Virtual sensing for strain estimation in wind turbine support structures based on a single accelerometer

Answer to the reviewer's comments

Figure 5: Displacement-to-strain [transmissibility function](#) $T_{w \rightarrow \epsilon}$ for different MDE approaches. All approaches are exact at the eigenfrequencies (EFs) but deviate from the continuous $T_{w \rightarrow \epsilon}$ between the EFs and below the 1. EF.

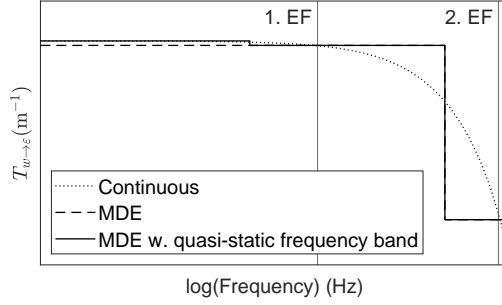
- It is maybe nitpicking but I would argue that the authors are using 'transmissibility' functions $T(\omega)$ to compute the virtual sensor, rather than transfer functions $H(\omega)$. A transfer function is a system property and independent of the load, it provides the relation between inputs and outputs, respectively forces and responses.

Opposingly, Transmissibility functions relate responses to other responses (even if they are different physical quantities, like strain and displacement) AND transmissibility functions depend on the localization of the forces.

In my reading, I would pose that the authors are using transmissibility functions. Fundamentally this doesn't change anything about the methods, but it might be relevant to consider for clarity to not use the term transfer function and the typical symbol H .

Thank you for this comments, which improved the correctness of the manuscript. The authors agree with the reviewer's comment on the terminology. Since we relate system outputs (displacements) to system outputs (strain), we are indeed using transmissibility functions. Even though this does not change the proposed methodology, we updated the terminology accordingly by replacing the words *transfer function* with *transmissibility function*. Since this occurs at multiple occasion, not all changes to the manuscript are included here. Furthermore, we adopt the proposed symbol T for the transmissibility function instead of H . Additionally we changed the axis description in Figure 5 (page 12 Figure 5):

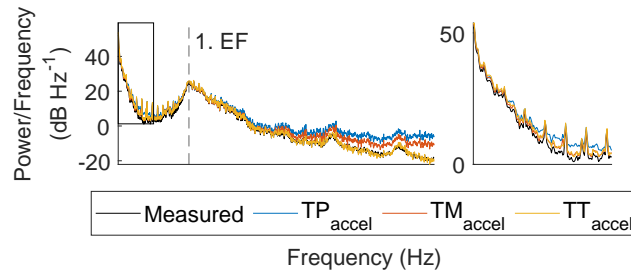
7. **Figure 17, I understand the authors have some requirement to normalize the scale, but it would be clear if the first mode is clearly indicated (not by number but just as a line). What are the spikes to the right of the black box? And how does the black box relate to the first mode (e.g. 25%?)**

The authors agree that an indication of the first modal frequency is helpful and updated the figure accordingly. Furthermore, we applied a window using 30000 samples for the calculation of the spectrum to make the deviations better visible. The cause of the spikes below the first eigenfrequency is not known to the authors. However they appear in both the measured and estimated strain signal. To enhance visibility, we extended the zoom on the right side to also include some of the spikes (page 25 figure 18):

Figure 17: 10 minute mean values of the yaw angle and wind speed during the considered period.

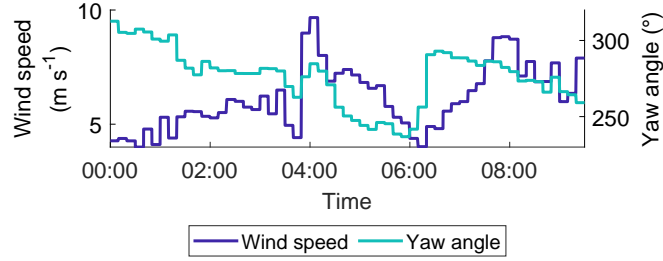
Can the orientation of the turbine at that time (nacelle position/yaw) and wind speed be indicated for that record?

We added a sentence (page 23 lines 454-455):

The high-pass filtered results of the proposed method for strain estimation are shown as an example in Fig. 16 for the strain gauge position at 35° next to the 10 minute mean values of the yaw angle and the wind speed in Fig. 17.

Figure 19: Error of the strain estimation at TP at 35° using the accelerometers at the TT, TM and TP. The shutdown event is highlighted in grey. (Figure not included in the manuscript)

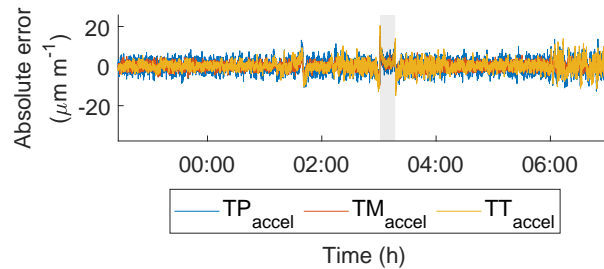
8. **Figure 18, is the settling of the error in the beginning of the time series linked to the high pass frequency?**

This is true, the settling of the error in the beginning of the time series is indeed linked to the high pass frequency. There is a very low frequency error which is in the authors opinion caused by low frequency drift in the measured strain and acceleration. To exclude this in the further analysis, we decided to apply a high pass

filter with a very low frequency (0.1 mHz corresponds to 3.4 cycles in the considered period). Since we are particularly interested in the quasi-static component, a higher cutoff frequency would not be meaningful. However, this low cutoff frequency also causes a slow settling. For comparison find the same Figure but with a cutoff frequency of 1 mHz below. Additionally, we added the following sentence to the manuscript (page 23 lines 455-457):

The long duration of the settling is caused by the low cutoff frequency; a higher cutoff frequency would reduce the error during the first hour.
